Subject: NYM/2021/0049/LB Additional details E11893-28 NYMNPA amendments 26.07.21

The Granary Suffield YO13 0BJ

D11893-03

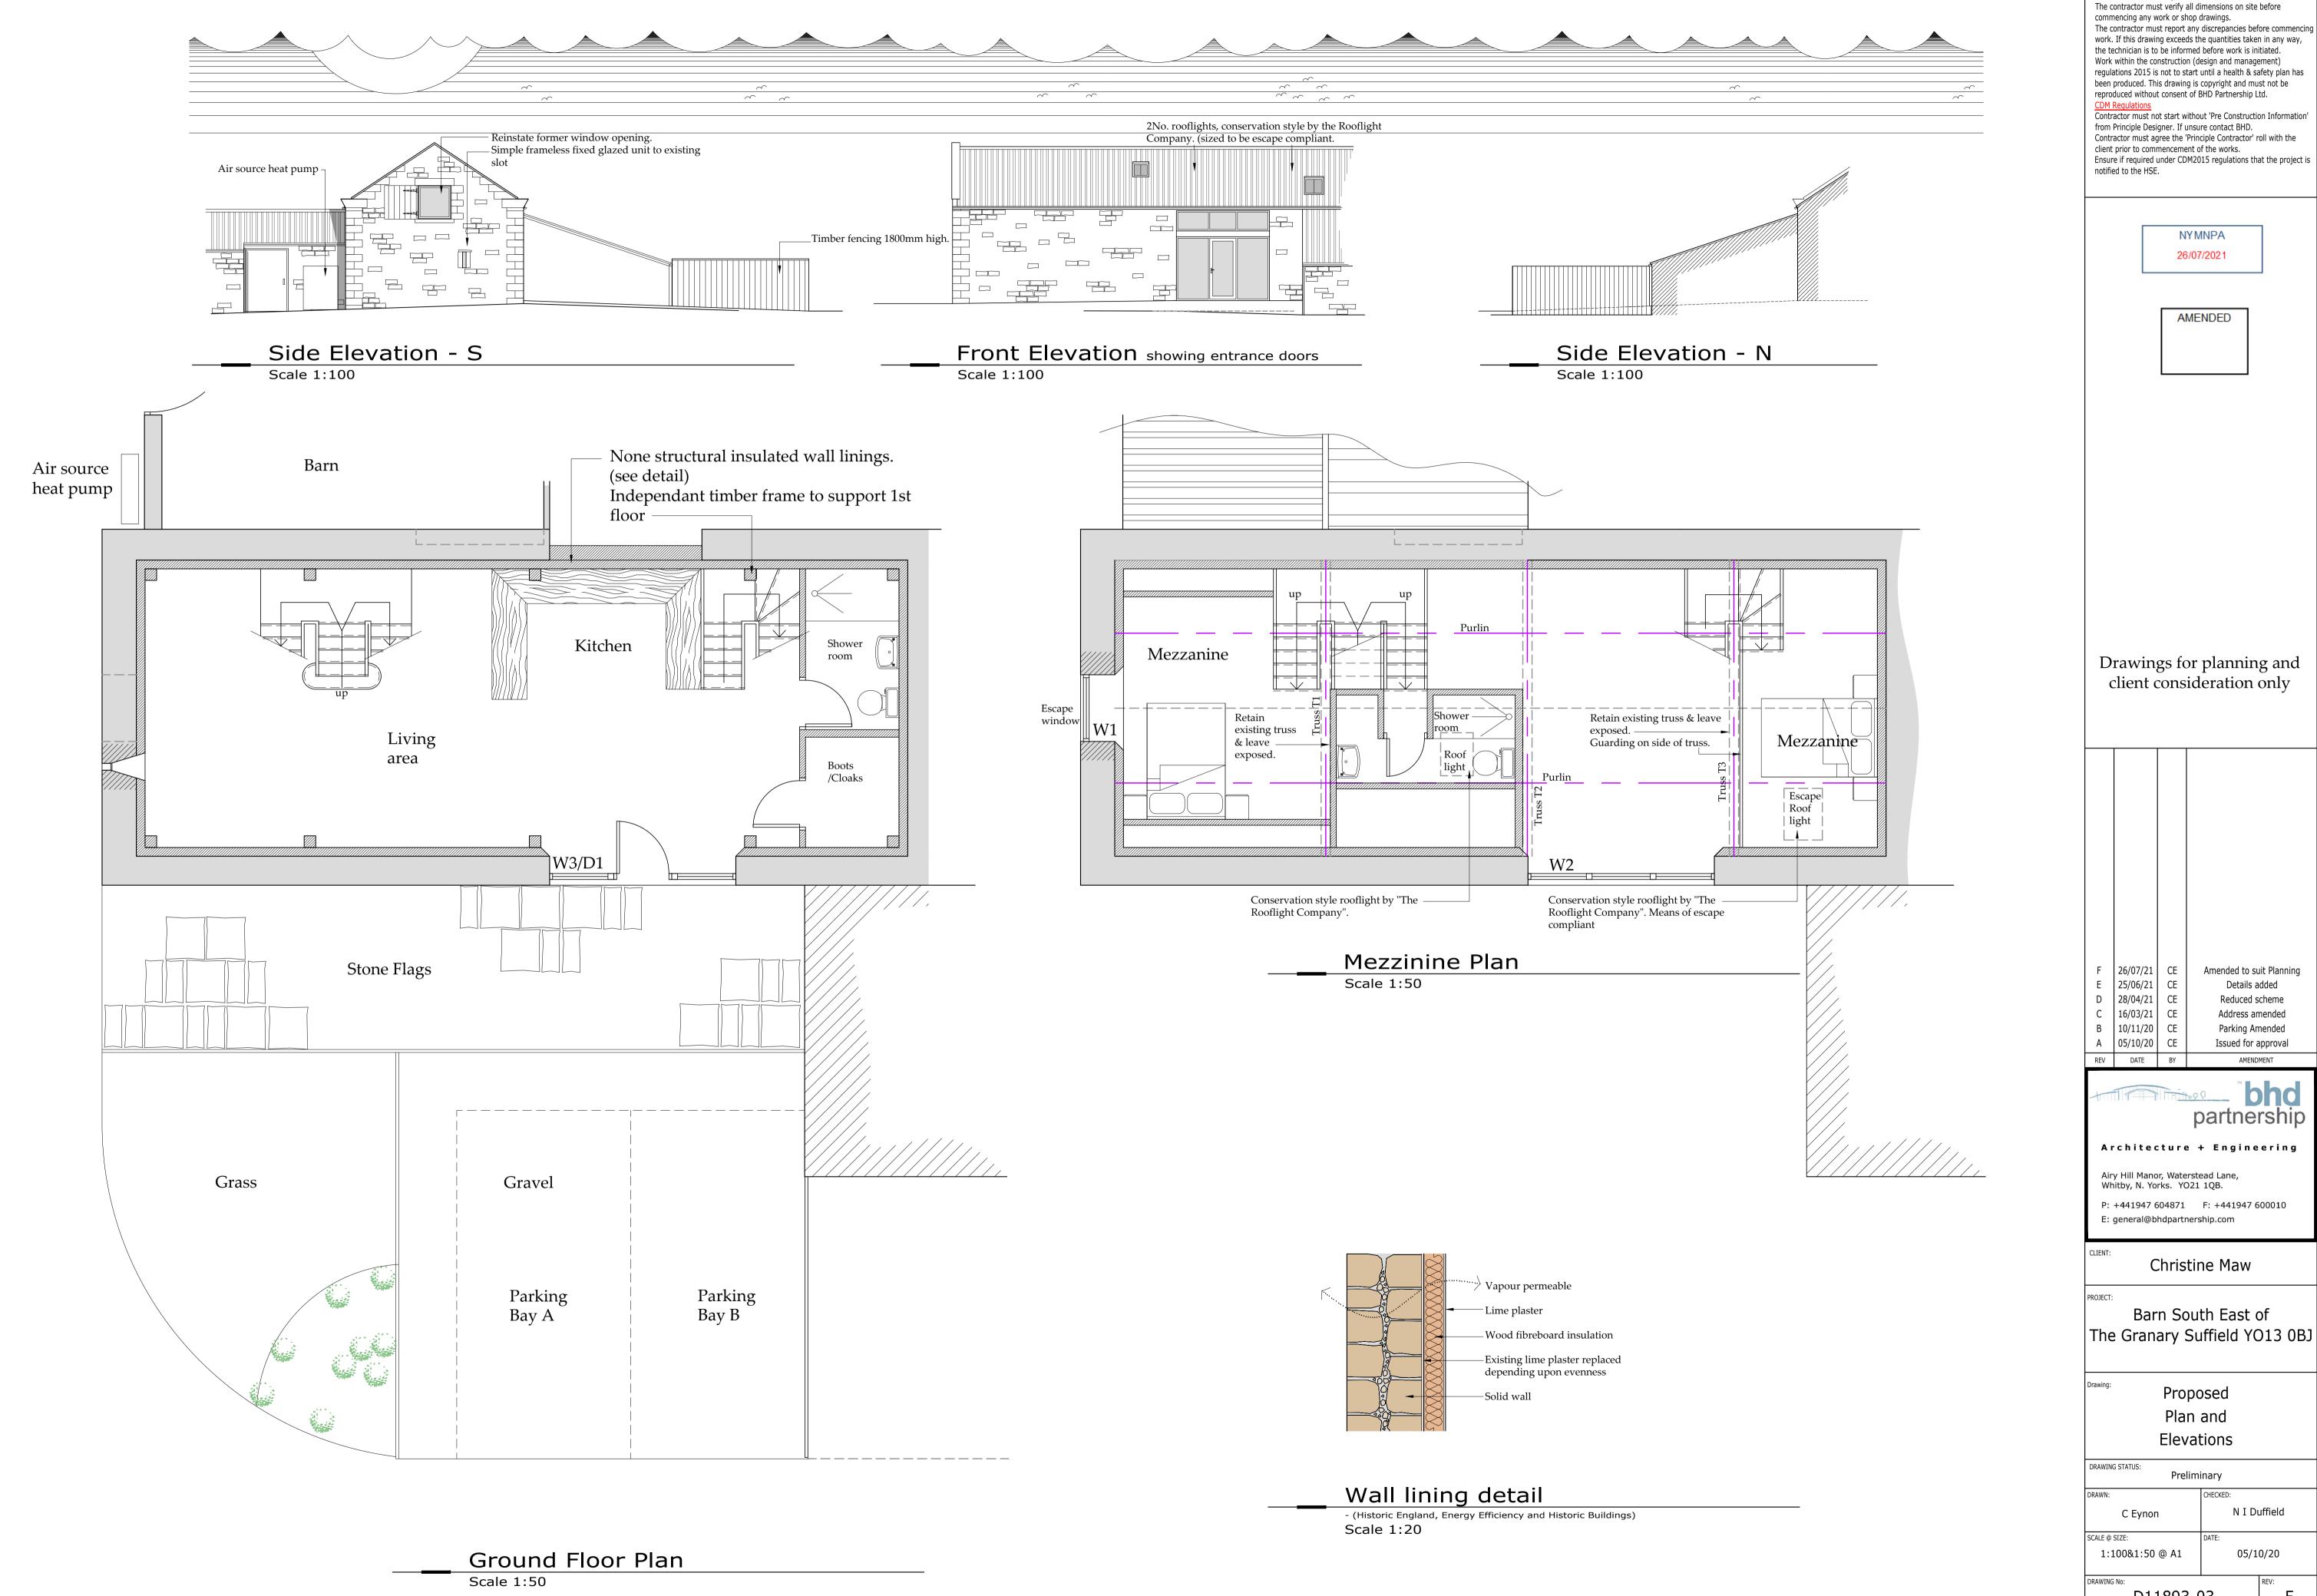
Following further liaison we have amended the scheme.

It is still a single Unit but a lot more open plan.

The sleeping areas are sat within the end Bays created by the trusses and a 3<sup>rd</sup> bay houses a shower room.

All trusses remain intact and are left visible.

Walls to the shower room and guarding to the bedrooms sit inside of the truss line.

The Bay abutting the Entrance is fully open to the underside of the roof.

The previous details noted such as a separate internal timber frame etc are still applicable.
